Well Name: LLAMA MALL 26-35 FEDERAL	Well Location: T22S / R32E / SEC 23 / SESE / 32.3726848 / -103.6410856	County or Parish/State: LEA / NM
Well Number: 35H	Type of Well: OIL WELL	Allottee or Tribe Name:
Lease Number: NMNM2379	Unit or CA Name:	Unit or CA Number:
US Well Number: 3002550299	Well Status: Drilling Well	Operator: OXY USA INCORPORATED

Notice of Intent

Type of Submission: Notice of Intent	Type of Action: APD Change
Date Sundry Submitted: 02/23/2023	Time Sundry Submitted: 09:20
Date proposed operation will begin: 05/01/2023

Procedure Description: OXY USA INC. respectfully request approval to amend the subject well AAPD by changing the Bottom Hole Location from 20 FSL & 330 FEL to 20 FSL & 440 FEL. Attached is the new plat, along with updated drill plan changes and supporting Drilling documents.

WELL LOCATION AND ACREAGE DEDICATION PLAT

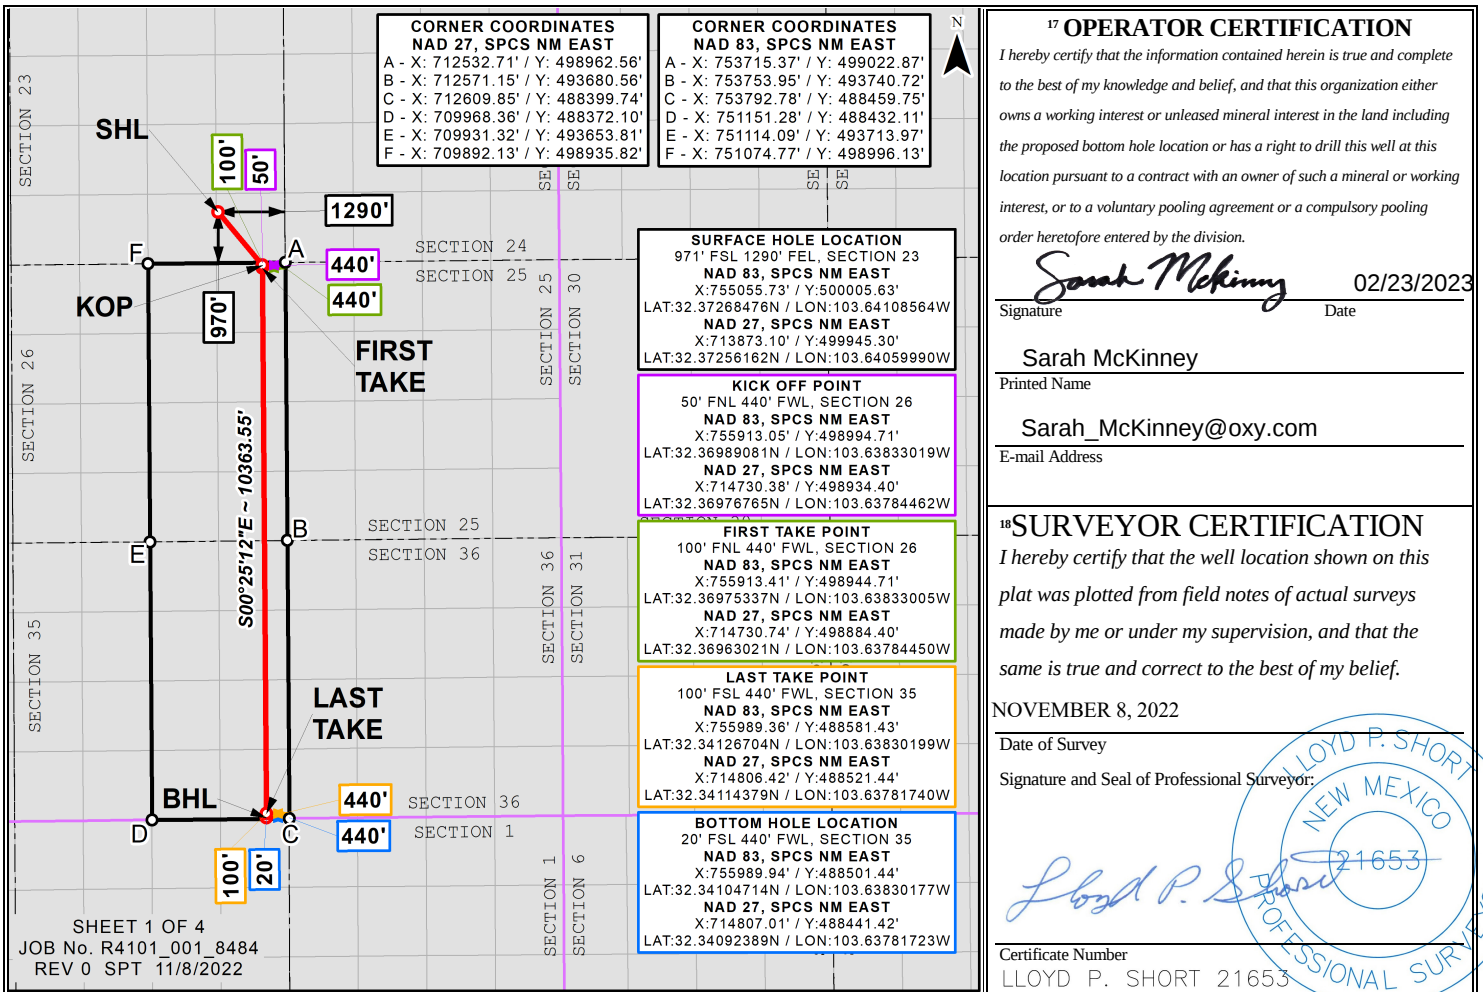
UL or lot no.	Section	Township	Range	Lot Idn	Feet from the	North/South line	Feet from the	East/West line	County
P	35	22S	32E		20	SOUTH	440	EAST	LEA
